# UNITED STATES PATENT AND TRADEMARK OFFICE

APPLICATION NO.	FILING DATE	FIRST NAMED INVENTOR	ATTORNEY DOCKET NO.	CONFIRMATION NO.
10/588,536	08/07/2006	Fernando Garofoli	06170-PCT-PA (0030.0567)	9569
<i>Hodes, Pessin + Katz, P.A. 901 Dulany Valley Road Suite 400 Baltimore, MD 21204</i>				EXAMINER
				FULTON, KRISTINA ROSE
ART UNIT		PAPER NUMBER		
		3673		
MAIL DATE		DELIVERY MODE		
09/29/2008		PAPER

<b>Office Action Summary</b>	Application No.	Applicant(s)
	10/588,536	GAROFOLI, FERNANDO
	Examiner KRISTINA FULTON	Art Unit 3673

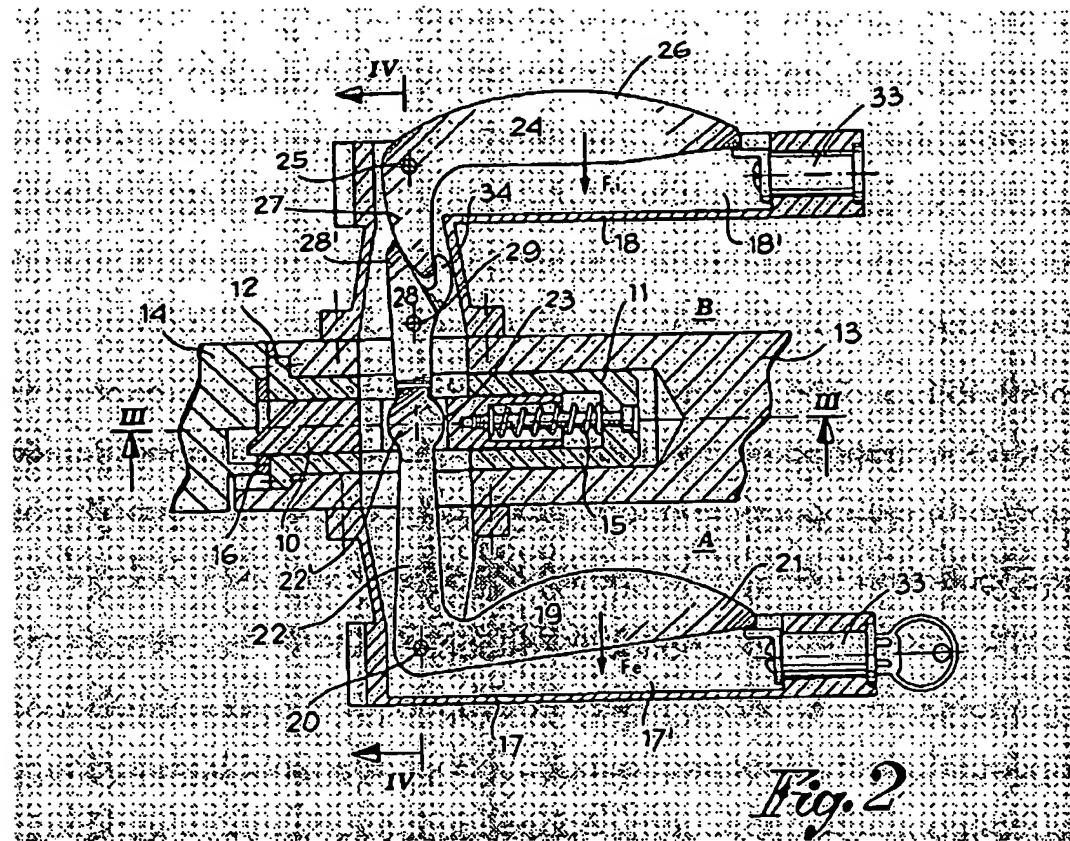
Claims 1-15 are rejected under 35 U.S.C. 102(b) as being anticipated by Pedersoli (DE4009764). "As best understood" Pedersoli shows internal and external handles (17 and 18) having an opening lever (22 or 27) and an opening button (26 or 21). The handle further include a vertical lever (28) having a fork (29). The device includes a spring (15) within a housing (11) and a latch mechanism (10). The door handle further shows a cylindrical chamber (at each end of handle for cylinder 33). The handle includes a cylinder (33) for locking the handle with a key (see illustration below). The handle is an L shape. See the Pedersoli device below.
